FINAL DRAINAGE REPORT
for
OWL MARKETPLACE FILNG NO. 1

Falcon, Colorado

August 2023

EPC's EDARP File
Number: VR2321

Figure 9-45. UDFCD modified USBR type VI impacts stilling basin (general design dimensions)

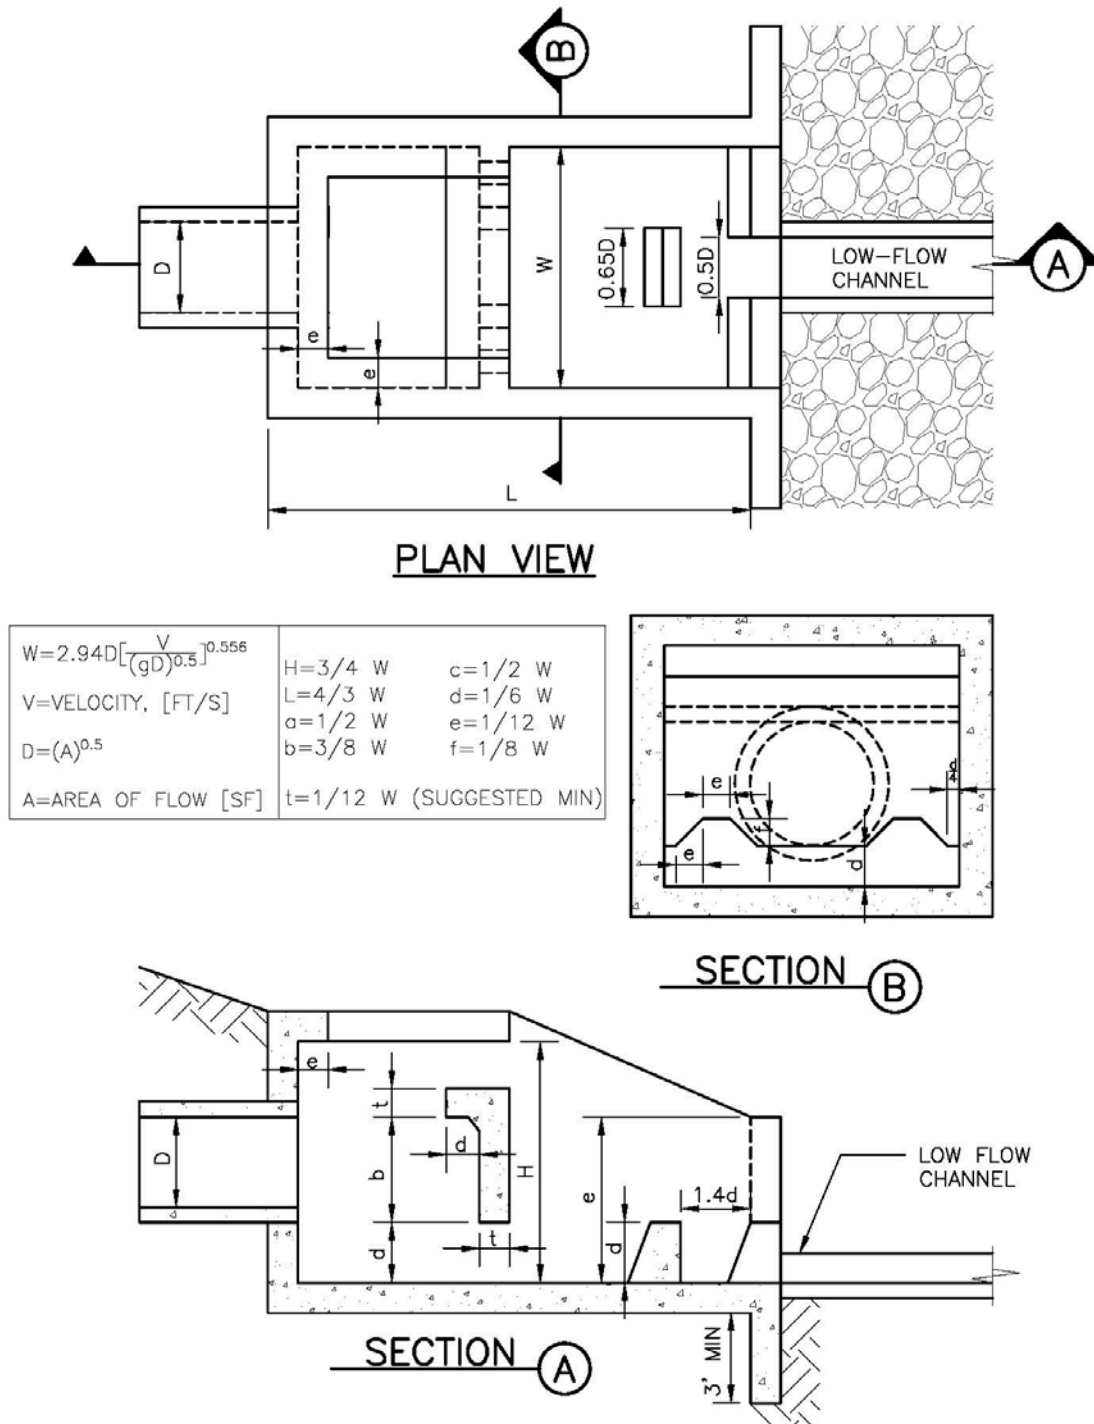
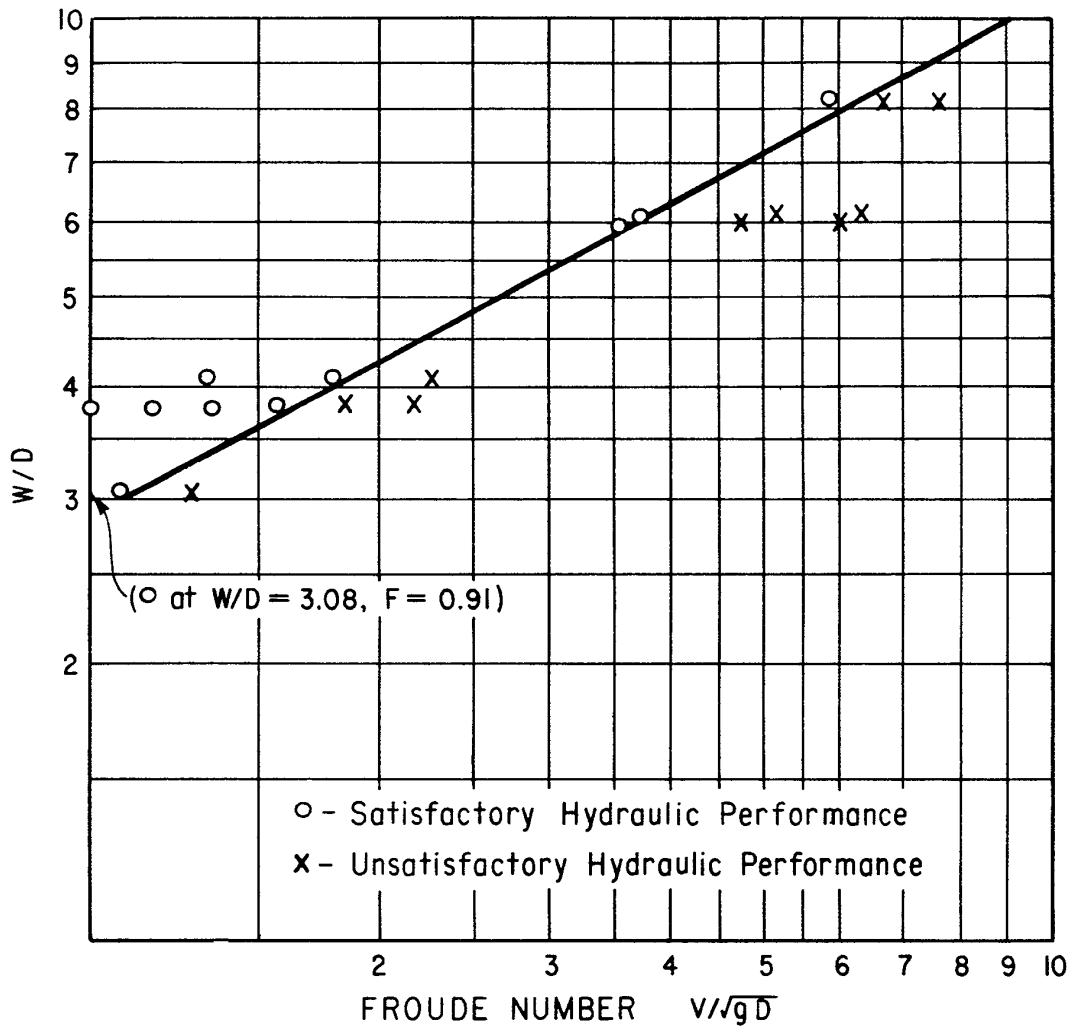
Provide complete design for the inlet structure to the box culvert, including safety features.

EXISTING DRAINAGE MAP
 PROJECT NO. 21611-01CSCV
 DRAWING NO.

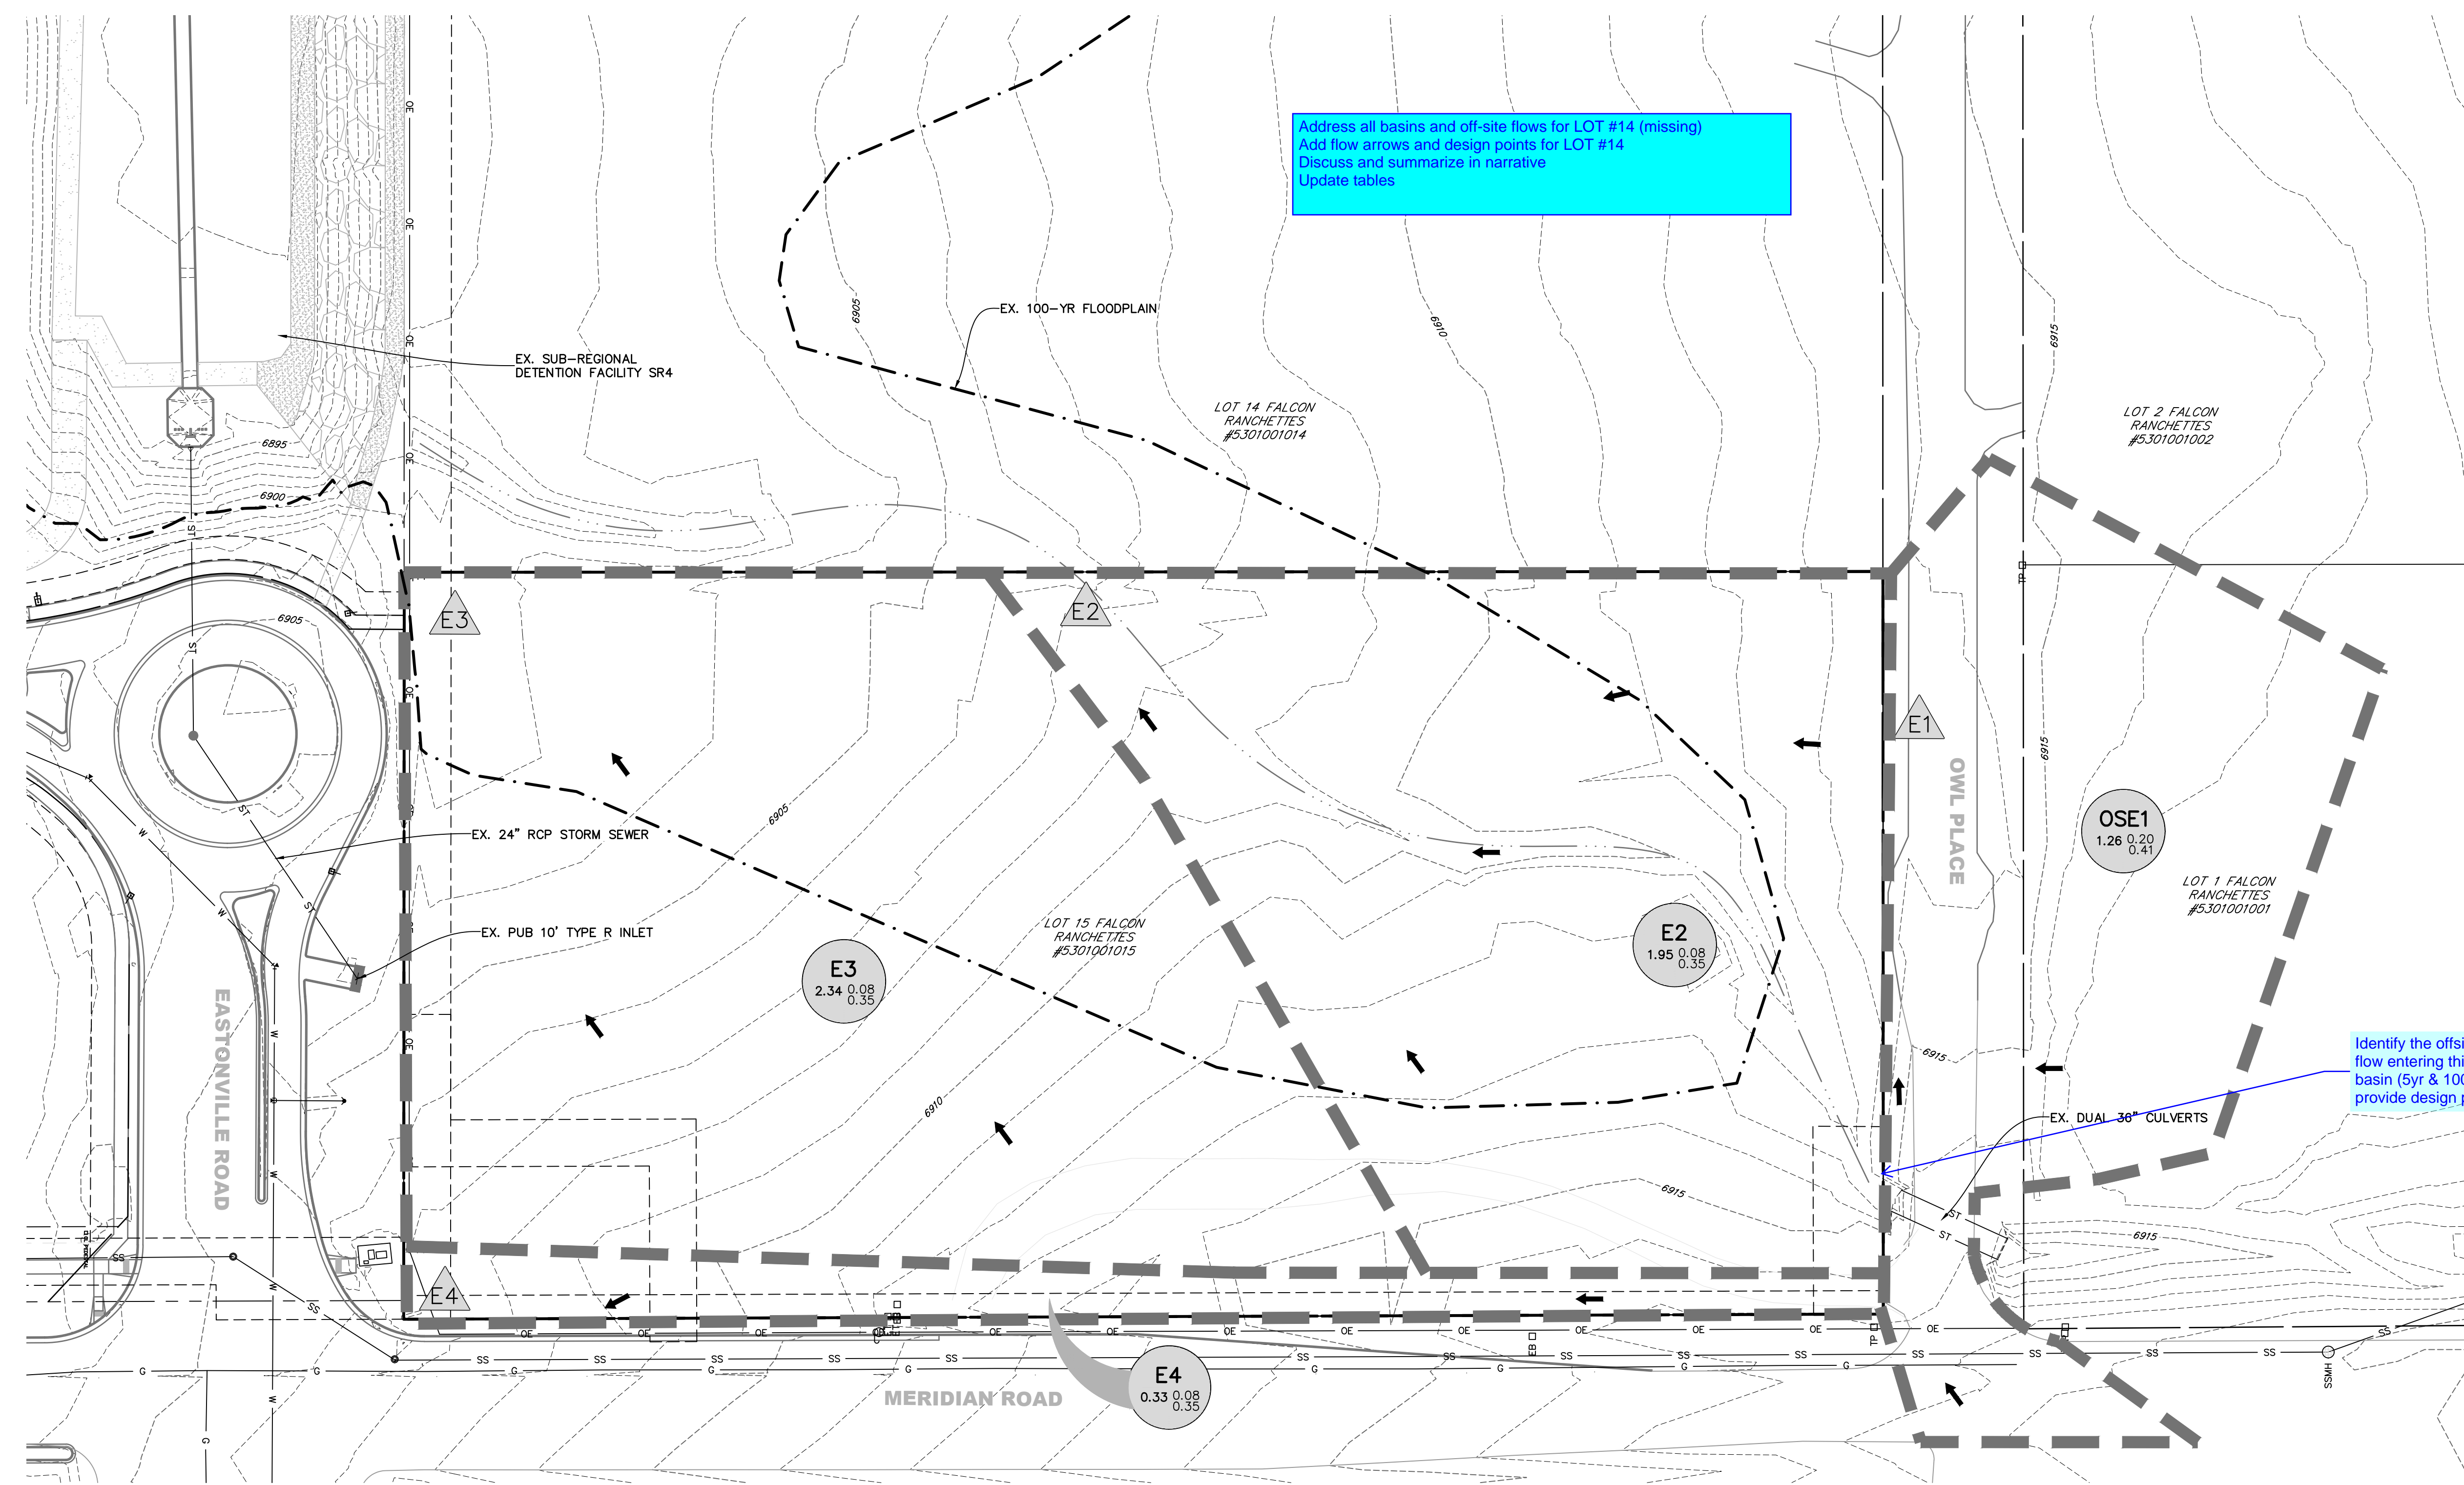
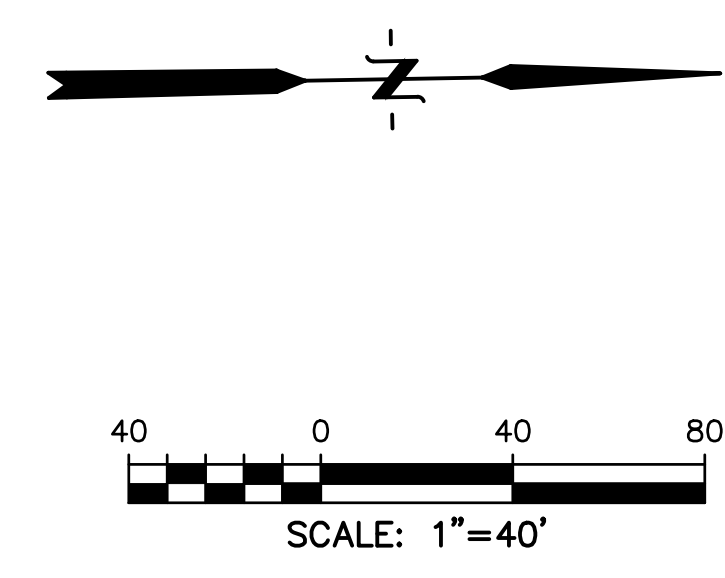
Address all basins and off-site flows for LOT #14 (missing)
 Add flow arrows and design points for LOT #14
 Discuss and summarize in narrative
 Update tables

Identify the offsite flow entering this basin (5yr & 100yr). provide design pt.

PROPOSED DRAINAGE MAP
 PROJECT NO. 21611-01CSCV
 DRAWING NO.

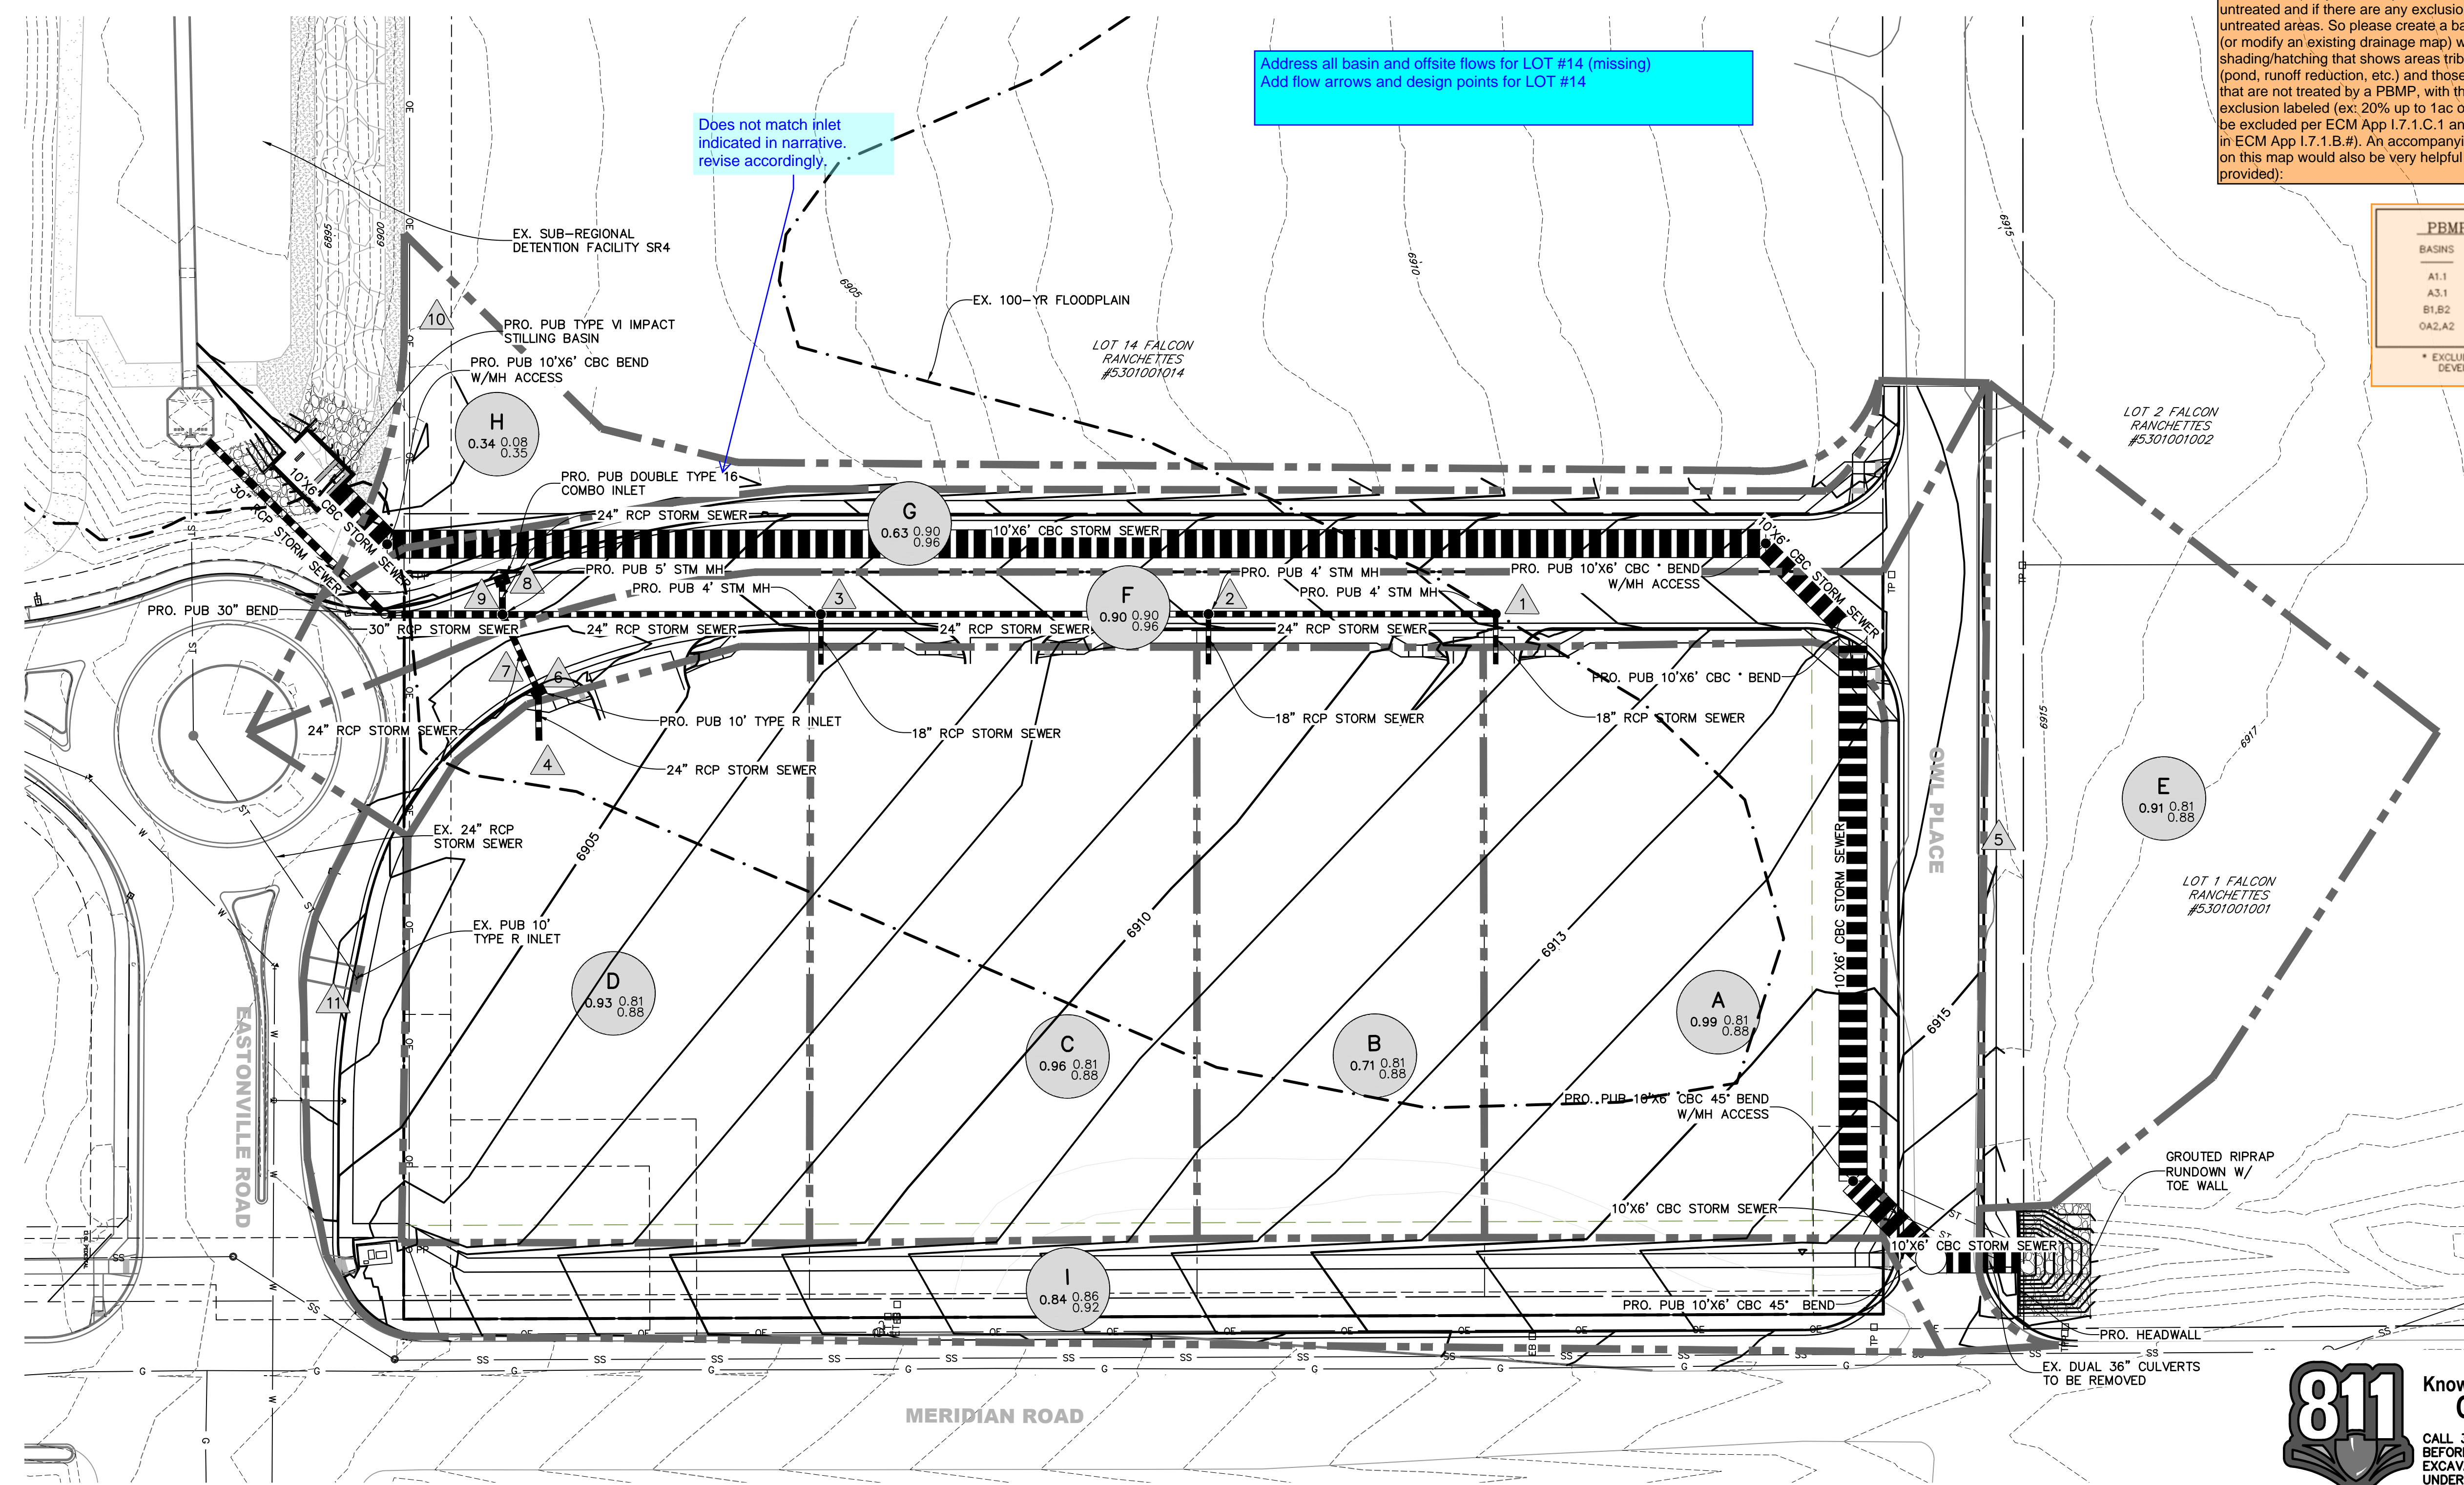
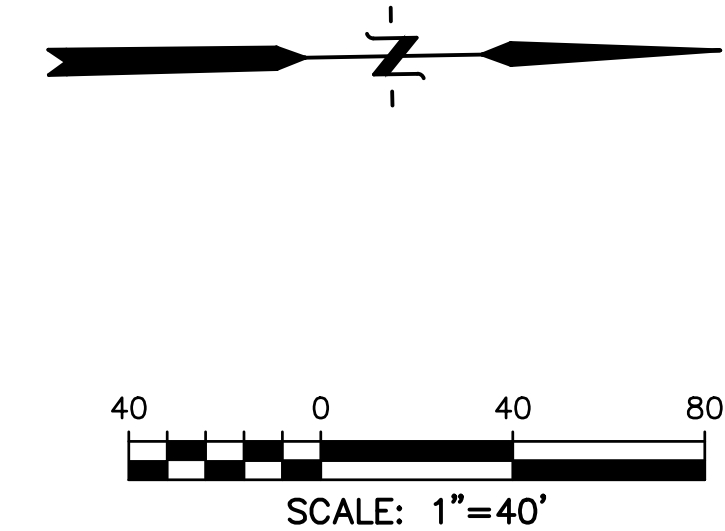
Regarding the drainage maps:
 We need to know how much of the proposed area of disturbance (not just the impervious surfaces) is treated vs untreated and if there are any exclusions that apply to the untreated areas. So please create a basic overview map (or modify an existing drainage map) with color shading/hatching that shows areas tributary to each PBMP (pond, runoff reduction, etc.) and those disturbed areas that are not treated by a PBMP, with the applicable exclusion labeled (ex: 20% up to 1ac of development can be excluded per ECM App 1.7.1.C.1 and exclusions listed in ECM App 1.7.1.B.#). An accompanying summary table on this map would also be very helpful (example provided):

Address all basin and offsite flows for LOT #14 (missing)
 Add flow arrows and design points for LOT #14

Does not match inlet indicated in narrative.
 revise accordingly.
